19 March 2015

Response to Submissions for SSD 6848 - Stage 3B of Lismore Base Hospital

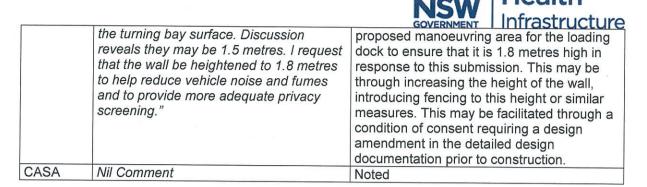
"Diagrams of the retaining wall indicate it

would be 2.3 metres above the level of

Amendments are able to be made to the

retaining wall at the northern extent of the
